Historic Preservation Design Review

HP-10-12, Dugan Street Parking Lot (City)

Request: Design review approval for proposed parking lot and landscaping for property located at 25-31 Dugan St.

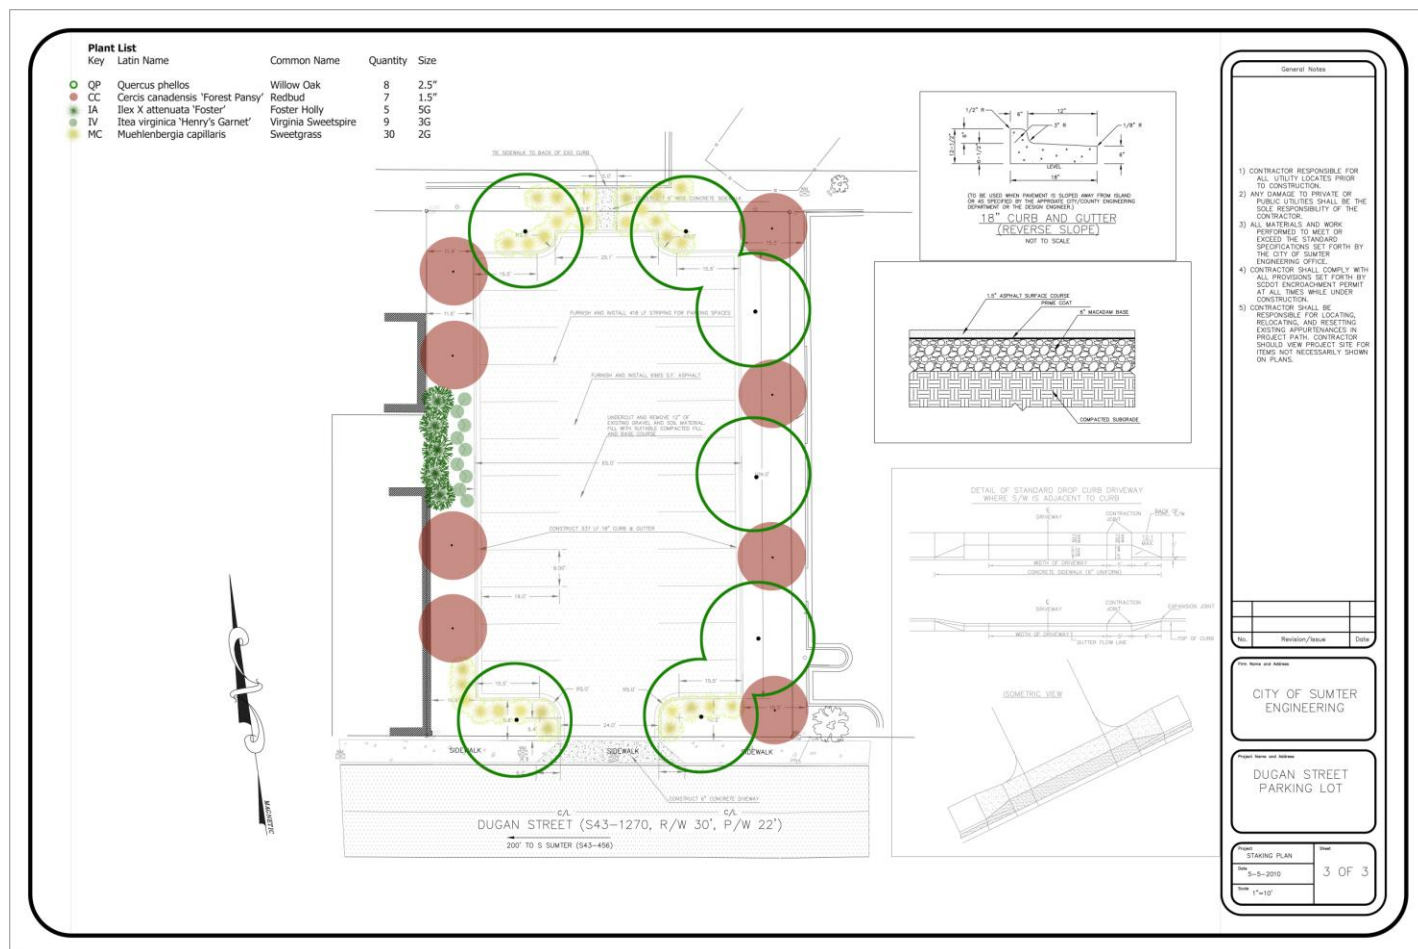
The site plan to the right shows the proposed layout for the parking lot. There are bufferyards proposed on all four sides a minimum of 10 ft. in width—these areas are indicated in green.

Highlighted in gray, a sidewalk is planned to connect these new 24 spaces with the larger parking lot to the north. There is no defined pedestrian connectivity to the parking lot on the east beyond the existing sidewalk at the southern end of the parking lot.

As shown in the landscape plan on below, the southern entrance to the lot will be buffered with a combination of Willow Oaks, Redbuds and sweet grass.

The depth of the proposed bufferyard sets the parking lot back behind the existing building plane on Dugan St. obscuring the parking lot from public view when looking from the Sumter St./Dugan St. intersection. A comprehensive landscape design has also been proposed to shield the appearance of the exterior wall of the remaining structure to the west of the parking area.

The proposed parking lot design maintains the building rhythm through landscape elements.

The tree and shrubbery selection for this plan are based on the location of the parking lot. This parking lot is located behind and between several structures and is a small portion of a larger downtown parking area. All planting beds and tree separation meet the above referenced criteria.
